**To:** Development Permit Panel  
**From:** Joe Erceg  
Manager, Development Applications  
**Date:** August 7, 2002  
**File:** DP 02-203209  
**Re:** **Application by Gomberoff Bell Lyon Architects for a Development Permit at  
7780/ 7820 Garden City Road**

## Staff Report

ELEVATIONS BLOCK 8

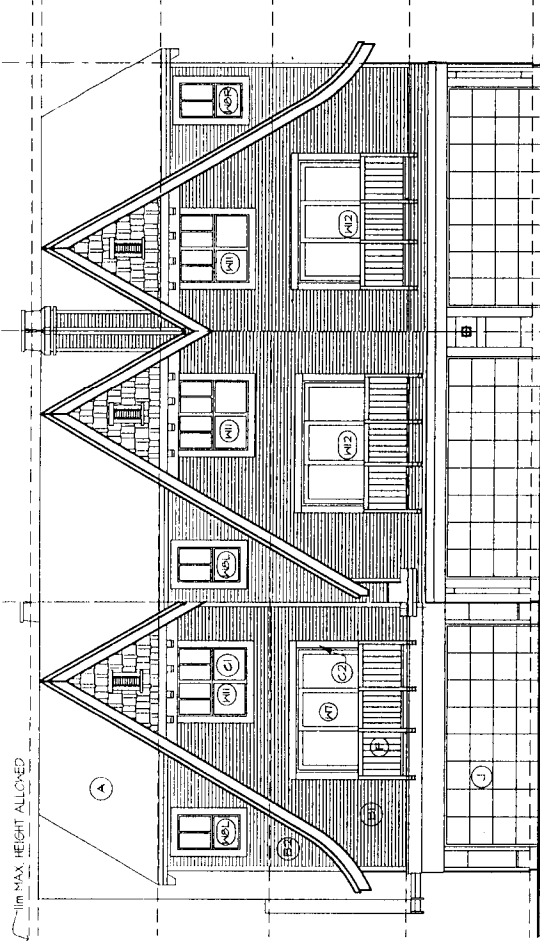
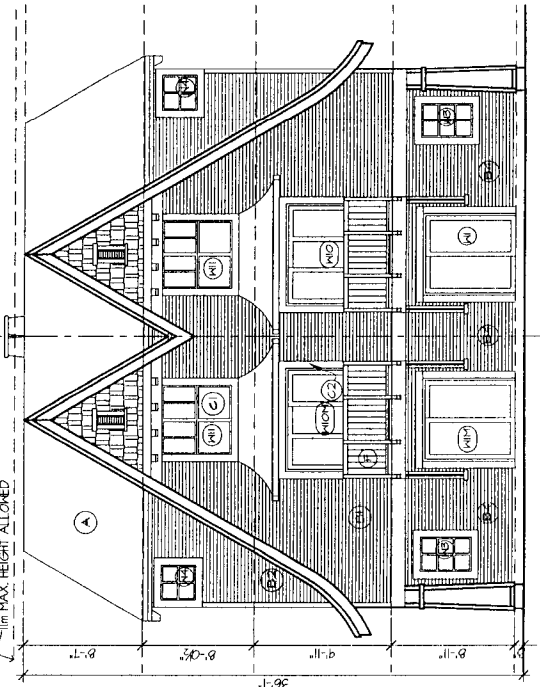
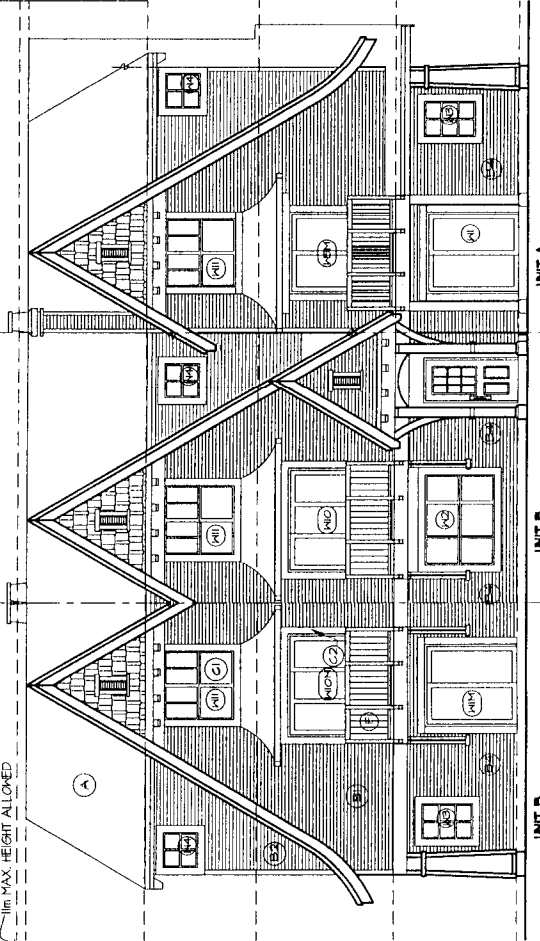
- ground plane is bare in places – no landscaping is evident along the road side;
- the lack of accessibility was noted;
- blocks 8 and 9 could be combined to allow for a widening of the entry;

ENTRY DETAIL  
1/4" = 1'-0"

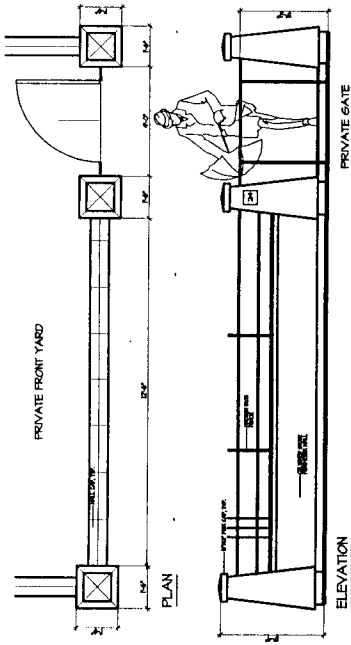
Comprehensive Development District (CD/127) states the public road setback required is 6m, with the balcony permitted to project 2m into the setback. The plans show the proposed setback at 5.8m. Mailbox gazebo does not meet the minimum 2m setback from the property line, and the maximum height allowed is 5m and the plans show proposed height is 6m. Variances required?

*The building setbacks have been revised to generally conform to the zoning regulations, and the height of the gazebo has been reduced to 5m.*
